Tennessee Valley Authority, 1101 Market Street, Chattanooga, Tennessee 37402

Sequoyah Nuclear Plant, Units 1 and 2
Facility Operating License Nos. DPR-77 and DPR-79
NRC Docket Nos. 50-327 and 50-328

**Subject: Response to NRC Request for Additional Information Regarding
the Review of the Sequoyah Nuclear Plant, Units 1 and 2, License Renewal
Application, Set 4 (TAC Nos. MF0481 and MF0482)**

ENCLOSURE 1
Tennessee Valley Authority
Sequoyah Nuclear Plant, Units 1 and 2 License Renewal
TVA Responses to NRC Request for Additional Information

EXHIBIT A
TYPICAL TEST CONNECTION DETAIL

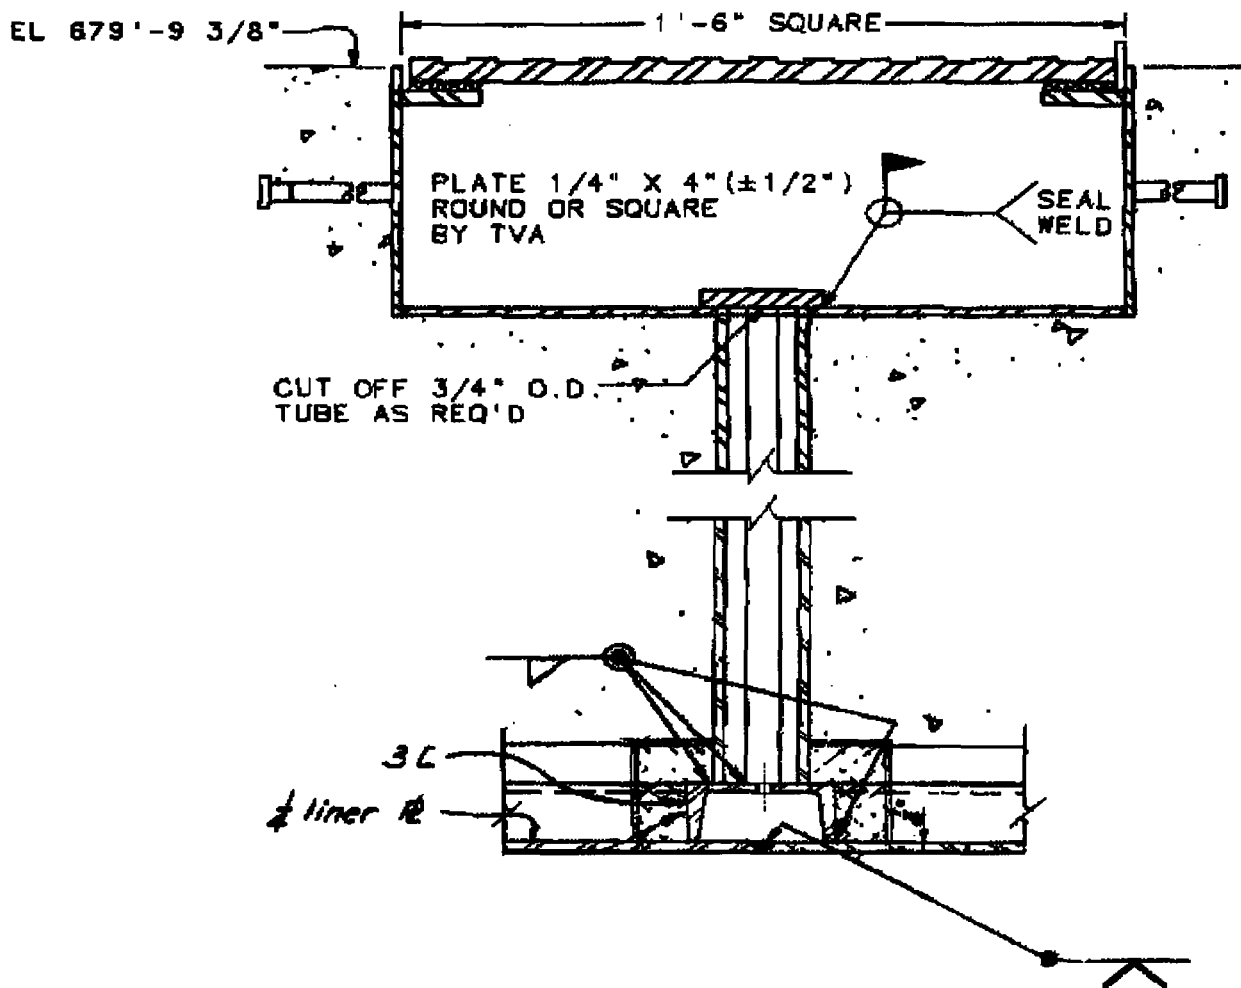
1. *The carbon steel pressure test piping that connect to the embedded leak chase channels in the containment base slab concrete were found to be corroded. Some of the pipes had through wall corrosion. The applicant has issued a design change notice (DCN) that allows, as an option, permanent sealing the pressure test piping by a steel plate after removing a portion of the piping. It is not clear how this change will prevent further corrosion of the pressure test piping, containment liner plate, including the full penetration welds in the base slab, and associated embedded leak chase channels.*

2. *During the audit, the staff reviewed photographs that show evidence of corrosion in the steel containment shell at the moisture barrier due to water leakage. The moisture barrier had been found to be degraded in certain areas. The water may have also leaked beyond past the degraded moisture barrier into the inaccessible area of steel containment embedded in the concrete resulting in corrosion of the liner plate.*

Discuss the actions the applicant has initiated or planned to ensure that the steel containment pressure boundary integrity will be maintained during the period of extended operation relative to the issues noted above. The response should include:

- 1. Details of any periodic tests to be performed on the liner plate and leak chase channel.*
- 2. Plans, if any, for an ultrasonic test (UT) examination of the steel containment below the moisture barrier from the annulus area, exposure of a portion of the embedded liner plate and rebars in concrete to determine the presence and extent of corrosion.*

1. The actions to ensure the steel containment vessel (SCV) pressure boundary integrity will be maintained during the PEO are detailed in LRA Table 3.5.2-1 and described in LRA Appendices B.1.6 and B.1.7. SQN plans to continue managing aging effects of the SCV and its attachments by conducting periodic inspections and testing in accordance with the Containment Leak Rate (10 CFR Part 50, Appendix J) and Containment Inservice Inspection – IWE programs. Details regarding the pressure test piping and the moisture barrier are provided as follows.

The leak test (leak chase) channel is a channel enclosing the SCV bottom steel liner plate welds on the containment side, which was designed to allow pressurization of the welds for post-installation pressure testing. The leak test channel and associated leak test connection are shown in Exhibit A "Typical Test Connection Detail" below. The potential paths for moisture into the leak test channel are through the $\frac{3}{4}$ inch diameter (dia) test connection tubing directly into the channel or through the annulus between the 2-inch dia pipe sleeve and the $\frac{3}{4}$ inch dia test connection tubing and then entering the channel through a flaw, if one exists. SQN plans to modify the configuration of the test connection access boxes to prevent moisture from entering the $\frac{3}{4}$ -inch dia test connection tubing or the annulus between the $\frac{3}{4}$ -inch tubing and the 2-inch dia pipe sleeve that encloses the tubing, thus preventing corrosion of the pressure test tubing, containment liner plate, including the full penetration welds in the base slab, and the associated embedded leak test channels. The design modification requires cutting the $\frac{3}{4}$ inch dia test connection tubing at the bottom of the access box and welding a steel cover plate over the opening as shown in Exhibit A below. This modification has already been installed in SQN Unit 2, and plans are in place to install a similar modification in SQN Unit 1. Prior to installing this design modification in SQN Unit 2, remote visual examinations were performed, to the extent possible, inside the leak test channels by inserting a borescope video probe into the test connection tubing. Similar inspections will also be performed prior to installation of the modification on Unit 1. Based on the satisfactory examination results to date, following installation of the design modification SQN has no plans to perform future visual examinations of the embedded SCV liner plate or embedded leak test channels.

TVA will modify the configuration of the SQN Unit 1 test connection access boxes to prevent moisture intrusion to the leak test channels. Prior to installing this modification, TVA will perform remote visual examinations inside the leak test channels by inserting a borescope video probe through the test connection tubing.
